Office Action Summary

10/551,802

DETAILED ACTION

Prior Art: Lee Figure 11

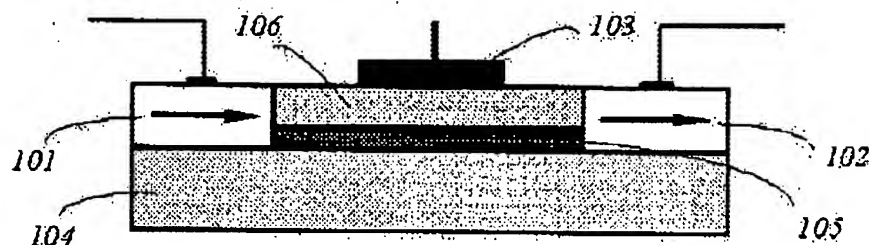
26. Per **Claim 35** Lee discloses a transistor, comprising a ferromagnetic semiconductor layer, a source (101) that injects carriers into the ferromagnetic semiconductor layer; and a drain (102) that receives the carriers injected into the ferromagnetic semiconductor layer a gate electrode (103) that applies a voltage for controlling conduction of the carriers from the source to the drain [0059]. Lee [0058] teaches that the ferromagnetic semiconductor material can be changed to have a ferromagnetic property or to have a non-ferromagnetic property by controlling a carrier concentration with a gate voltage. With this understanding, the device of Lee discloses combinations of ferromagnetic and/or non-ferromagnetic sources and drains.

27. Per **Claims 37 and 42** Lee discloses the transistor of claim 35, including where when the source is the ferromagnetic source, the drain is a non-magnetic drain that comprises a non-magnetic tunnel barrier (106) joined to the ferromagnetic semiconductor layer, and a non-magnetic electrode (103) joined to the non-magnetic tunnel barrier .

28. Per **Claims 38 and 43** Lee discloses the transistor of claim 35, including where when the drain is the ferromagnetic drain, the source is a non-magnetic source that comprises a non-magnetic tunnel barrier (106) joined to the ferromagnetic semiconductor layer, and a non-magnetic electrode (103) joined to the non-magnetic tunnel barrier .

31. Per **Claim 41** Lee discloses the transistor of claim 35, including where one of the source and the drain is a ferromagnetic source (101) or a ferromagnetic drain (102) that comprises a ferromagnetic tunnel barrier (106) joined to the ferromagnetic semiconductor layer (105), and a non-magnetic electrode (103) joined to the ferromagnetic tunnel barrier .

32. Per **Claim 44** Lee discloses the transistor of claim 35, including where the source (101) and the drain are a ferromagnetic source (101) and a ferromagnetic drain (102) each comprising a ferromagnetic tunnel barrier (106) joined to the ferromagnetic semiconductor layer, and a non-magnetic electrode (103) joined to the ferromagnetic tunnel barrier .

41. Per **Claim 51** Lee discloses the transistor of claim 35, including where an insulating layer (106) is interposed between the gate electrode (103) and the ferromagnetic semiconductor layer (105).

44. Per **Claims 55 and 57** Lee discloses the transistor of claim 54, including where the transistor is formed on the substrate; the junction interface of the source and the drain in the vicinity of the gate electrode is substantially perpendicular to the principal surface of the substrate; and the flowing direction of the carriers moving from the source to the drain is in a plane substantially parallel to the principal surface of the substrate. (As shown in figure 11)

45. Per **Claim 56** Lee discloses the transistor of claim 54, including where the electrode (103) is separated from the ferromagnetic semiconductor layer (105) and the substrate (104) by the tunnel barrier (106).

46. Per **Claim 61** Lee discloses the transistor of claim 54, including where the transistor is formed on the substrate; the junction interface of the source and the drain with the ferromagnetic semiconductor in the vicinity of the gate electrode is substantially parallel to the principal surface of the substrate; and the flowing direction of the carriers moving from the source to the drain is in a plane substantially parallel to the principal surface of the substrate. (see figure 11)
